## STAFF MEMORANDUM

Meeting Date: **Wednesday, January 12, 2022**  
DATE: January 7, 2022  
TO: Urban Design Commission  
FROM: Shubee Sikka, Urban Designer  
SUBJECT: **Additional Review Information**

1 MALL FACADE - PROPOSED ELEVATION  
SCALE: N/A

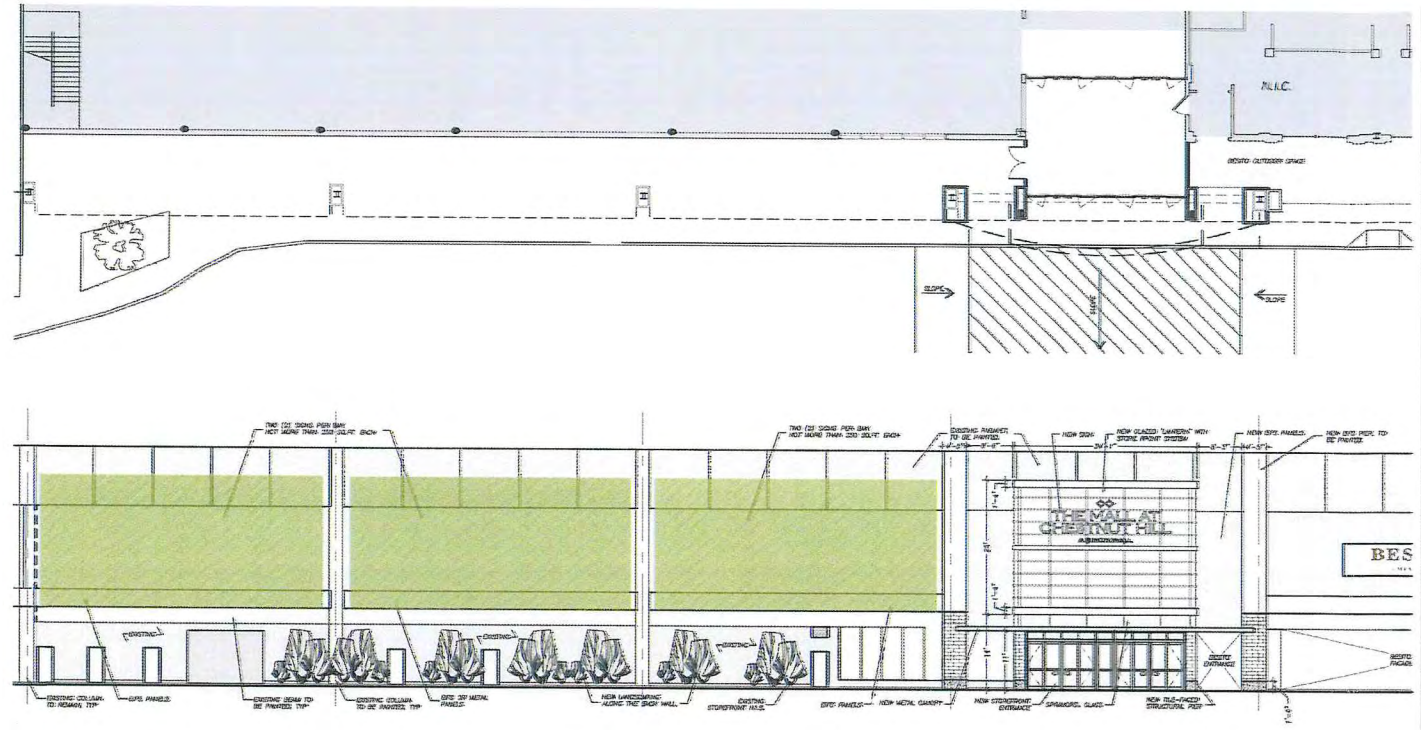
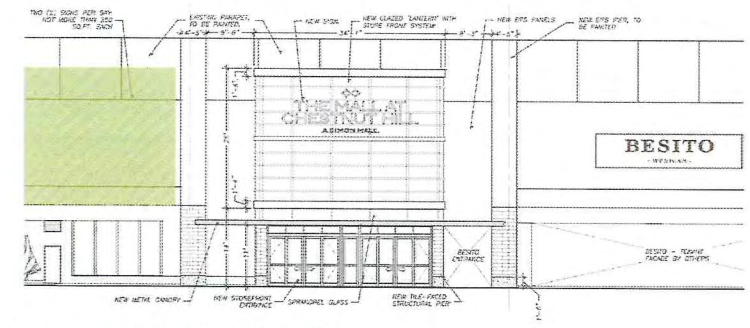
- The three proposed awning mounted secondary signs appear to be not consistent with the dimensional controls specified in §5.2.8. Per the Zoning Ordinance, two secondary signs are allowed, which the applicant is exceeding, and they are also not allowed to be on the same wall as the principal sign. The signs also do not appear to be consistent with the sign package approved by Board Order #474-14. Applicant will need to apply for an amendment to the special permit to allow these signs.

STAFF RECOMMENDATION: Staff recommends approval of the proposed principal sign. Staff seeks recommendation from UDC regarding the proposed awning mounted secondary sign to the Land Use Committee of the City Council.

49 Boylston Street  
West Elevation

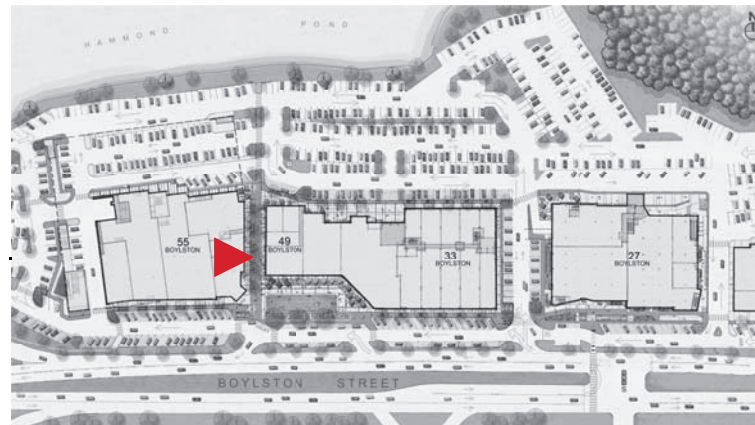
- Both the proposed split principal signs appear to be consistent with the dimensional controls specified in §5.2.8. Per the Zoning Ordinance, one principal sign is allowed, which the applicant is not exceeding, and on this façade of 21 feet, the maximum size of the sign allowed is 63 sq. ft., which the applicant is also not exceeding. Per Zoning Ordinance §5.2.8, *“In particular instances, due to the nature of the use of the premises, the architecture of the building, or its location with reference to the street, the total allowable sign area may be divided between two wall signs which together constitute the principal wall sign.”* However, the proposed sign is not consistent with the comprehensive sign package (attachment C), both signs are outside the sign band.

**STAFF RECOMMENDATION:** Staff seeks recommendation from the Commission regarding the proposed signs to the Commissioner of Inspectional Services.
